Re: FortisBC Energy Inc. (FEI)

**Application for a Certificate of Public Convenience and Necessity (CPCN) for
Approval of the Interior Transmission System Transmission Integrity
Management Capabilities Project (Application)**

**Response to the British Columbia Utilities Commission (BCUC) Information
Request (IR) No. 2**

Number of Line Damages to FEI Transmission Systems per 1,000 Transmission Locates (2017 - 2022)

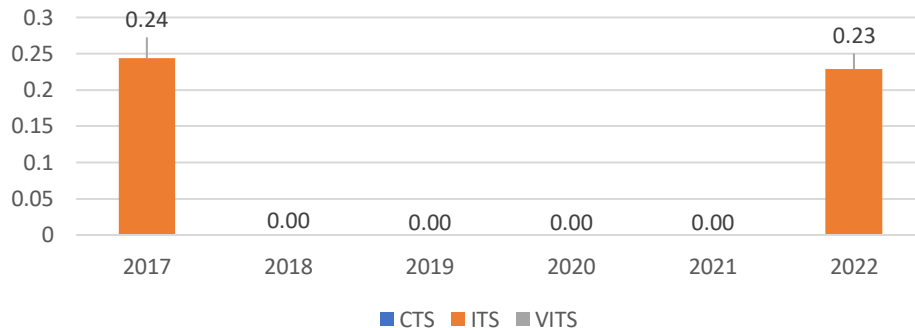
18.1 Please provide a figure, similar to the figure above, showing the number of line damages per 1,000 line locate requests by FEI transmission system (Costal Transmission System (CTS), ITS, Vancouver Island Transmission System) for the years 2017 to 2020.

18.1.1 Please discuss any differences in line damage results between FEI transmission systems.

FEI had a total of two third-party line damages¹ to its transmission system between the years 2017 and 2022, both to the ITS. This information is represented in the graph below as a rate per thousand transmission locates. These events are sufficiently infrequent that FEI does not consider there to be any material differences in line damage results between FEI transmission systems.

Please note that the information in the chart from the Canadian Gas Association in the preamble is primarily driven by damages to, and the number of locates on, distribution systems, rather than transmission systems.

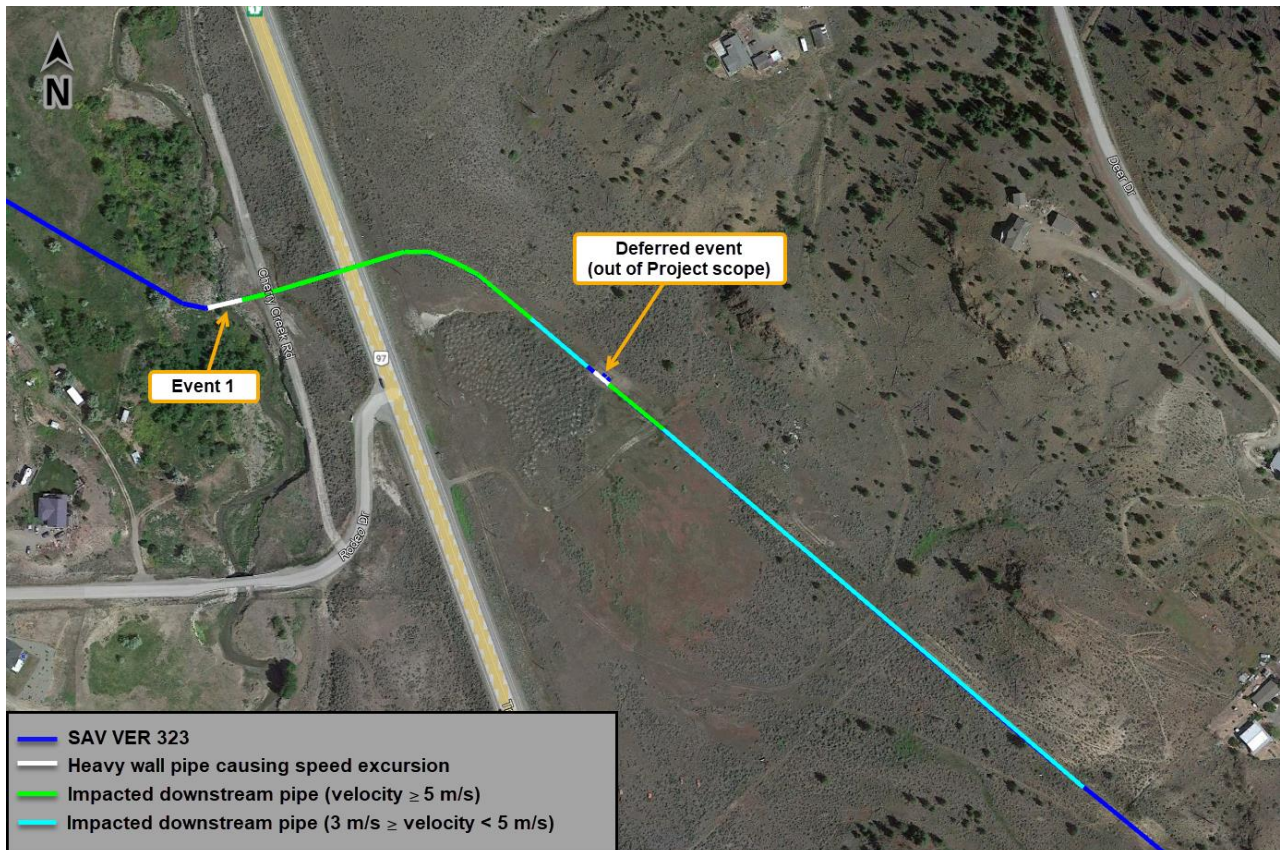
The following image, which is also provided in the response to BCUC IR2 22.1, shows the cause of the speed excursions, as well as its severity in alignment with Section 3 of Appendix F to the Application. The image illustrates how short the segment of heavy-wall pipe causing the speed excursion is in relation to the impacted downstream pipe. If FEI were instead required to mitigate cracking on the downstream impacted pipe (after obtaining unusable data collected by the EMAT ILI run), FEI would need to expose significantly more pipe than the proposed heavy-wall modification. Moreover, exposing the downstream pipe may also require replacement of the Trans-Canada Highway crossing, resulting in higher costs.

FEI notes that the image below also shows an example of a deferred heavy-wall replacement. Unlike Event 1, this heavy-wall segment did not cause the MFL-C tool to travel above its maximum velocity for data collection (7 m/s). As a result, and due to the shorter length of the speed excursion, FEI chose to defer replacement of the heavy-wall pipe at this location for the following reasons:

- The tool may nonetheless gather usable data if it only marginally exceeds the maximum velocity for full resolution data;
- It may be more cost-effective to mitigate cracking after the EMAT ILI run due to the relative lengths and terrain; and
- There may be improved tool performance through the deferred heavy-wall segment as a result of mitigating the upstream speed excursion through the replacement of Event 1.

Event 29 – KIN PRI 323

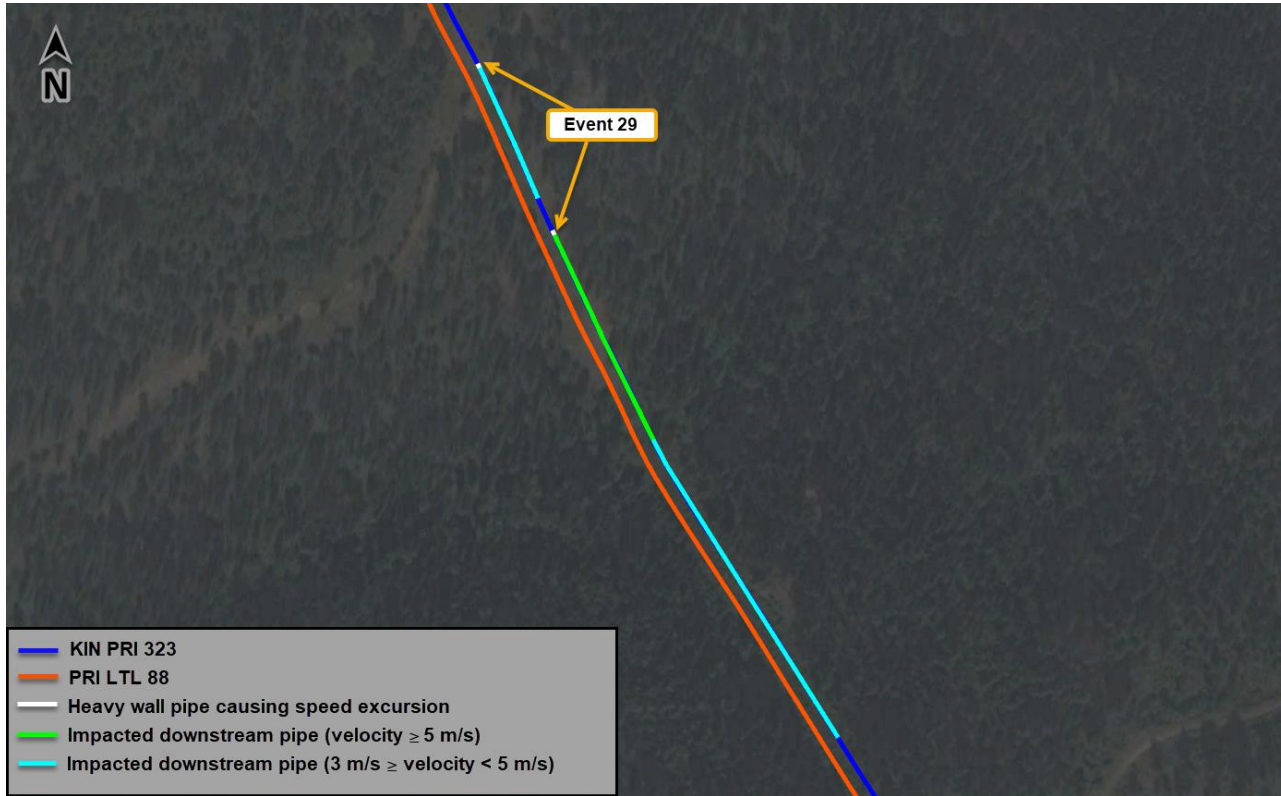
The following image, which is also provided in the response to BCUC IR2 22.1, shows that the segments of heavy-wall pipe causing the speed excursion are much shorter in relation to the impacted downstream pipe. If FEI were instead required to mitigate cracking on the downstream impacted pipe (after obtaining unusable data collected by the EMAT ILI run), FEI would need to expose significantly more pipe, resulting in higher costs.

Figure 1: Event 1 – SAV VER 323

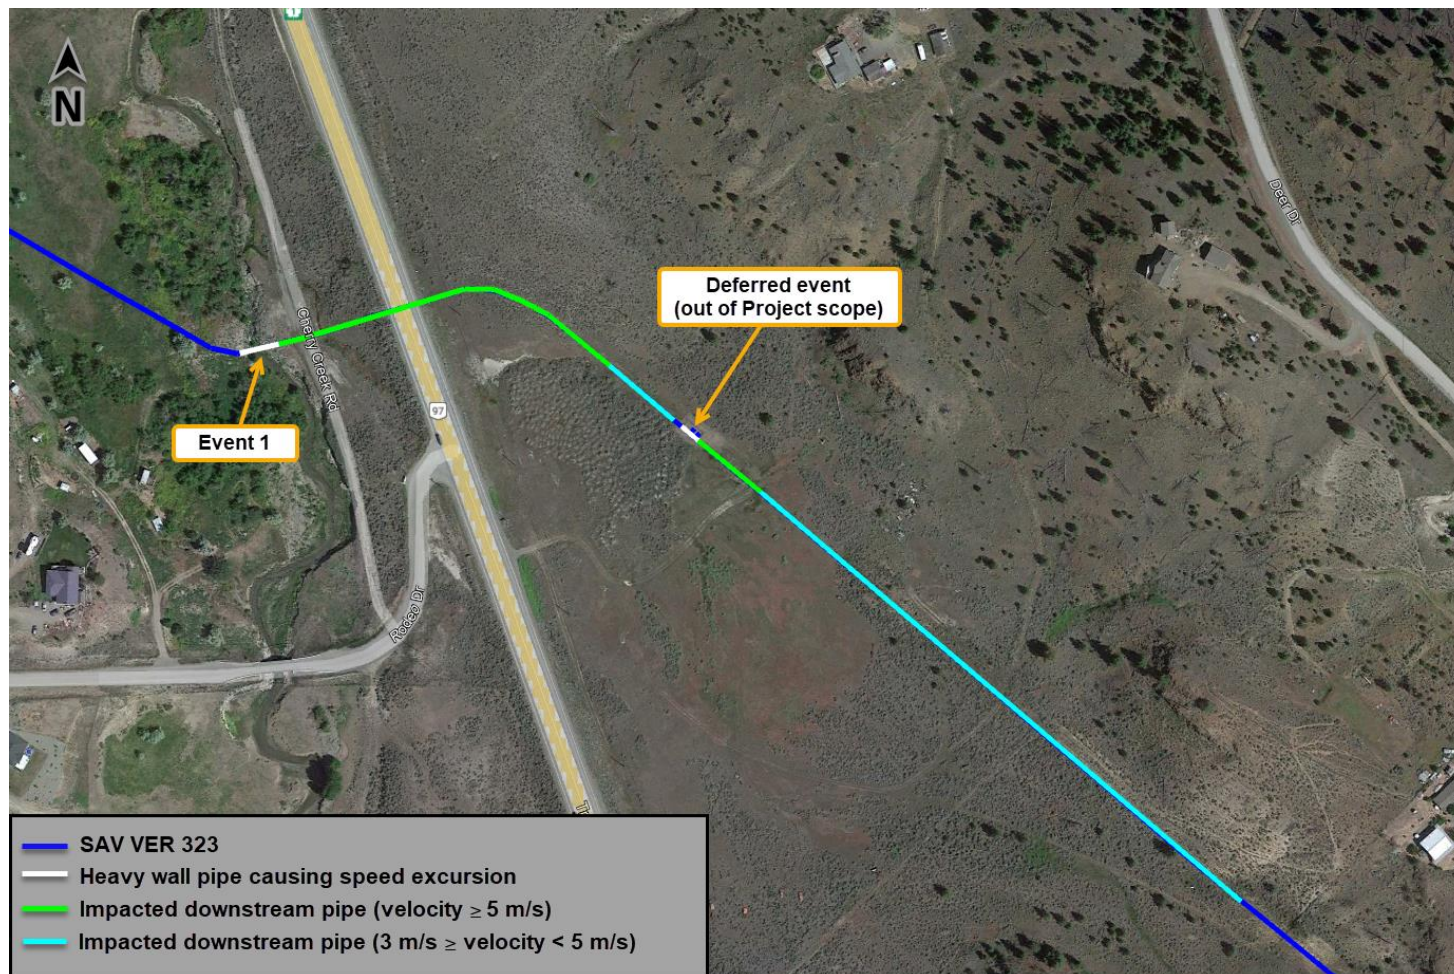
9 22.1 Please provide similar images illustrating the “Heavy wall pipe causing speed
10 excursion” and “impacted downstream pipe” for the locations of “Heavy-Wall Pipe
11 Modification Scope” included in Table 5-4 of the Application.

14 Please refer to the figures below in relation to each of the three proposed heavy-wall pipe
15 modifications included in Table 5-4 of the Application. Corresponding velocity plots are also
16 provided in the response to RCIA IR2 21.3.
